City and Borough of Sitka

Planning and Community Development Department

Re: P 16-02 Final Plat Minor Subdivision – Cedars Subdivision– 211 Shotgun Alley

DRAINAGE BASIN AREA
- NOT TO SCALE -

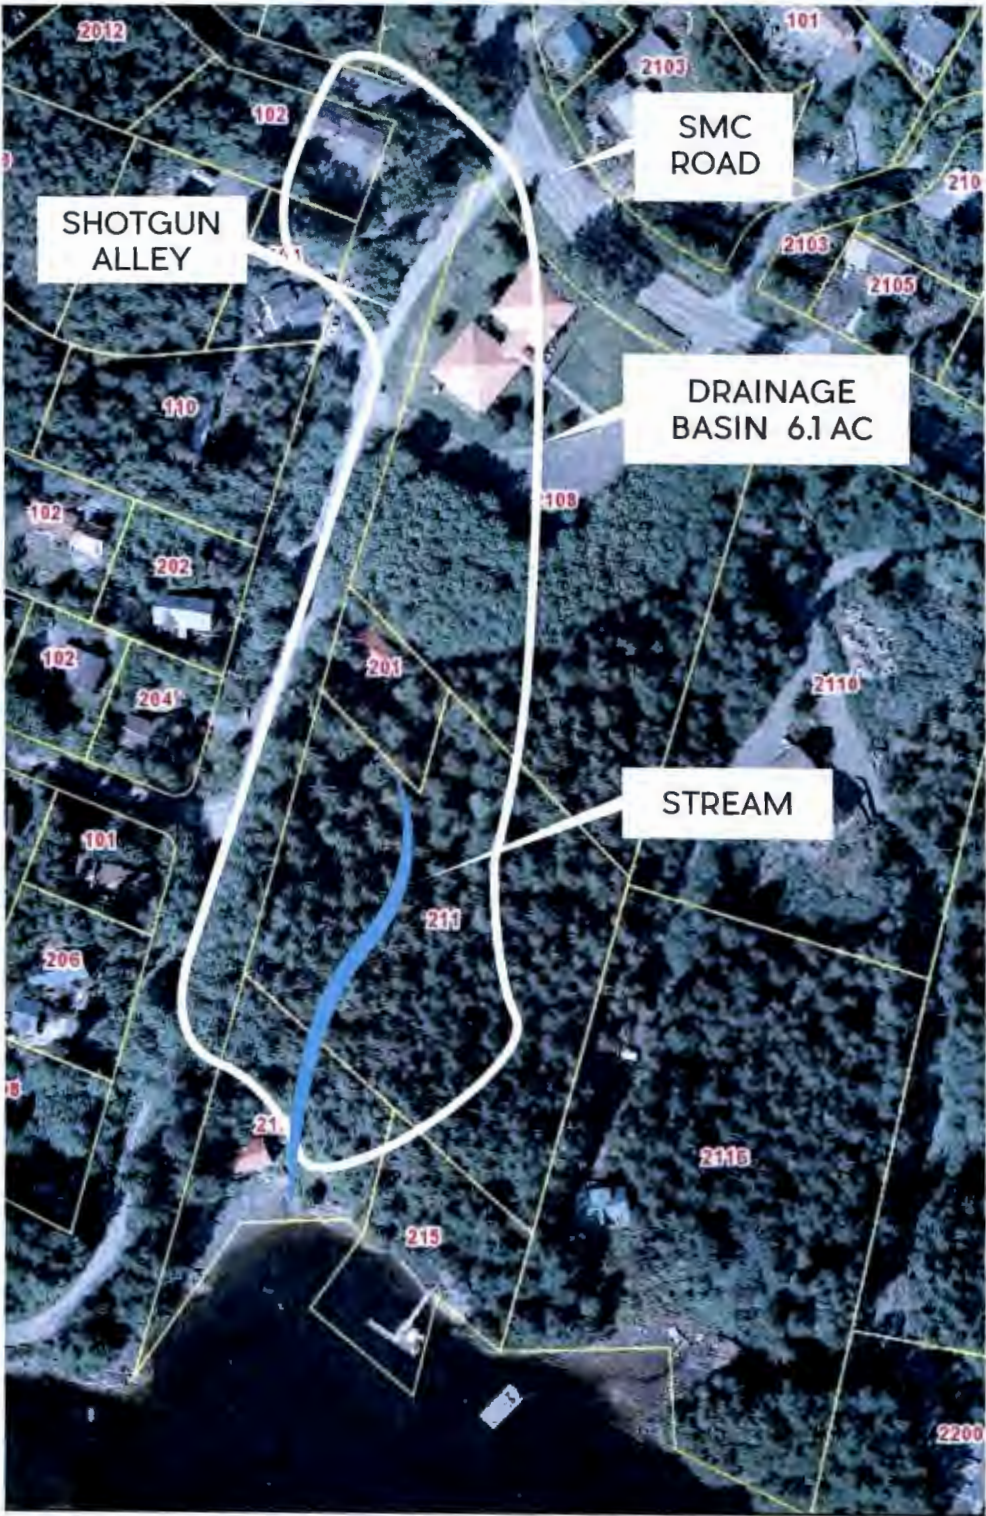
1. The new report requires page numbers
2. The new report addresses overall drainage basin which includes the upstream area contributing to the project area. The discussion of the Drainage Basin Areas on page 3 indicates 5.71 acres where the summary on this sheet shows 6.1 acres. The 5.71 value is only for Lot 211 not the total.

Our prior comments on the 211 Shotgun Alley Subdivision Drainage Report have been addressed. The revised report dated July 10, 2016 is satisfactory. No further comments to offer.
